**STATE OF CALIFORNIA  
REGIONAL WATER QUALITY CONTROL BOARD  
CENTRAL COAST REGION**

**STAFF REPORT FOR REGULAR MEETING OF JULY 14, 2011**

**SUBJECT:** Waste Discharge Requirements for the Olin Aquifer Containment and Cleanup System, Santa Clara County (Order No. R3-2011-0209)

#### Staff's Calculations for Estimated Increase in Nitrate from Tennant Well:

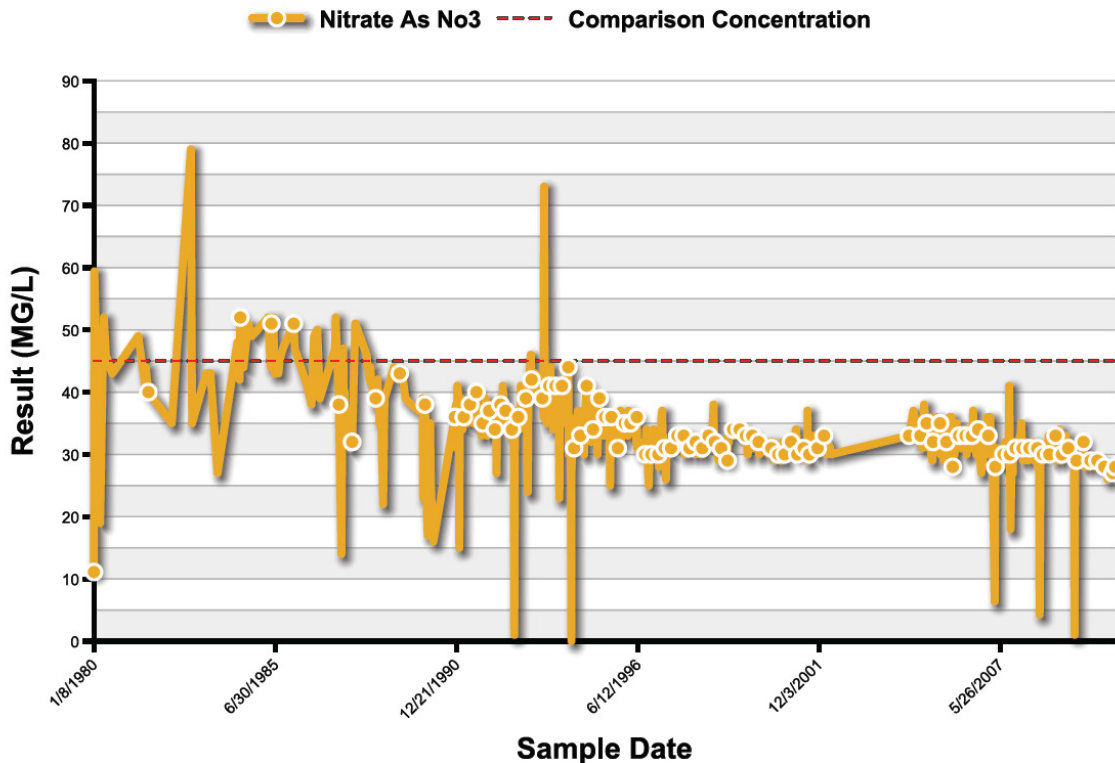
**3) General Comment from Olin regarding Impact of Reinjection on Tennant Well and in response to comments in draft WDR on Page 7, finding 15, tenth sentence; Page 9, finding 22, second paragraph; and Page 14, Ordering Paragraph B, point #2 (graph) –** *In the Draft WDR, the Water Board estimates that at the proposed quarterly and monthly nitrate discharge limits, on-Site reinjection of treated groundwater may have the potential to increase nitrate concentrations by up to 2 mg/L as nitrate. As noted in the attached comments, the method used to calculate the percent increase is incorrect and overestimates the potential effect of recharge on the nitrate concentration at the Tennant Well (which Olin earlier replaced by paying the cost of installing the higher capacity San Pedro Well in 2005). Applying the correct mathematical formula (described in the attached comments), the potential impact of on-Site reinjection on nitrate concentrations in the Tennant Well is estimated to be less than 0.5 mg/L, which is negligible compared to the temporal and spatial fluctuations of nitrate concentrations in the Llagas Subbasin.*

**Staff's Response:** Staff used conservative assumptions and calculations to estimate the nitrate increase in the Tennant Well. Staff "rounded up" the calculated nitrate increase in the Tennant well to 2 mg/L (see detailed calculation below). So, our conservative estimate is that nitrate in the Tennant Well will potentially increase from its current concentration of approximately 28 mg/L to 30 mg/L nitrate, which is within the temporal fluctuations (e.g., changes in nitrate concentrations due to seasonal changes in water table fluctuations, changes in spatial distribution of nitrate in groundwater, accuracy and precision of analytical analysis, etc.) of nitrate in the Tennant Well. Regardless, Olin's monitoring of nitrate concentrations in the shallow, intermediate, and deep aquifers in the vicinity of the Tennant Well will have sufficient spatial and temporal density to verify that actual nitrate concentrations are not different than the predicted changes of nitrate within each aquifer. Based on the concerns expressed in comments from other stakeholders, staff plans to modify MRP No. R3-2008-0028 before ACS startup (ACS startup scheduled for spring 2012) to ensure sufficient nitrate monitoring locations and frequency.

Current average concentration of nitrate in the shallow aquifer:.....24 mg/L  
 Estimated maximum long-term nitrate discharge concentration: .....38 mg/L  
 Resultant maximum shallow aquifer nitrate concentrations (100% discharge): .....38 mg/L  
 Change in shallow aquifer nitrate concentration over 10 years:..... 38-24 = 14 mg/L  
 Resultant change in Tennant Well concentration: ..... 14/10 (dilution factor) = 1.4 mg/L  
 Rounded up to the nearest integer:..... **2 mg/L**
